# Access Compliance Report

## Public Rights-of-Way

Intersection ID: 13985	Main Street: CAMDEN_RD	Cross Street: EAST_BV	Location: SE
ADA ID: 9AAFD0896423	Ramp Type: Perp	Initial Pass/Fail: Fail	Overall Compliance: No
Codes/Mitigation Info/Possible Solution		Field Measurements/Component Compliance	
Severity Score: 13.75

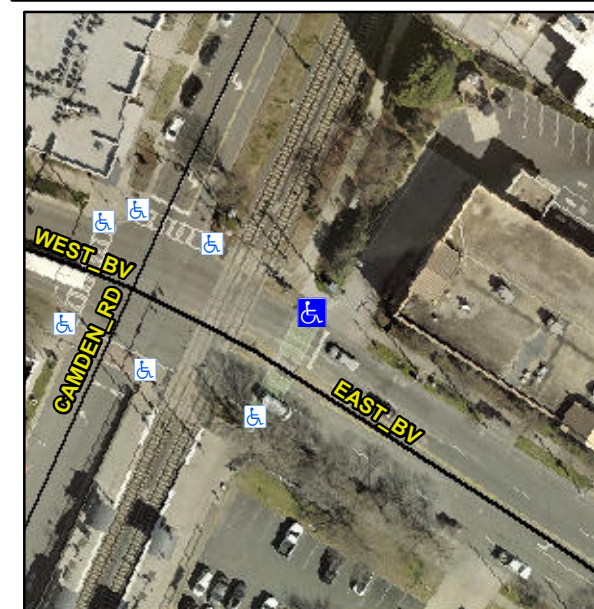
**Remove & Replace Entire Ramp.**

**R304.2.2, R304.5.3**

Compliance	Description	Data	Compliance	Description	Data
N/A	Ramp Length (in)	78.0	No	Ramp Slope (%)	8.9
Yes	Ramp Width (in)	98.0	No	Ramp XSlope (%)	2.8
N/A	Flare Type LT	N/A	N/A	Flare Type RT	N/A
N/A	Flare Slope LT (%)	N/A	N/A	Flare Slope RT (%)	N/A
N/A	Flare Traversable LT?	N/A	N/A	Flare Traversable RT?	N/A
N/A	Landing Length (in)	N/A	N/A	DWS Provided?	N/A
N/A	Landing Width (in)	N/A	N/A	DWS Contrast?	N/A
N/A	Landing Slope (%)	N/A	N/A	DWS Length (in)	N/A
N/A	Landing X Slope (%)	N/A	N/A	DWS Full Width?	N/A
N/A	Landing Curb? (Y/N)	N/A	N/A	DWS Offset (in)	N/A
N/A	Shared Landing?	N/A			
N/A	Gutter Ponding?	N/A	N/A	Gutter Slope (%)	N/A
N/A	Gutter Lip Ht (in)	N/A	N/A	Gutter X Slope (%)	N/A
N/A	Painted X Walk1?	Yes	N/A	Painted X Walk2?	N/A
	X Walk 1 Direction	To SW		X Walk 2 Direction	N/A
N/A	X Walk 1 Width (in)	144.0	N/A	X Walk 2 Width (in)	N/A
	X Walk 1 Slope (%)	2.9		X Walk 2 Slope (%)	N/A
	X Walk 1 X Slope (%)	0.7		X Walk 2 X Slope (%)	N/A
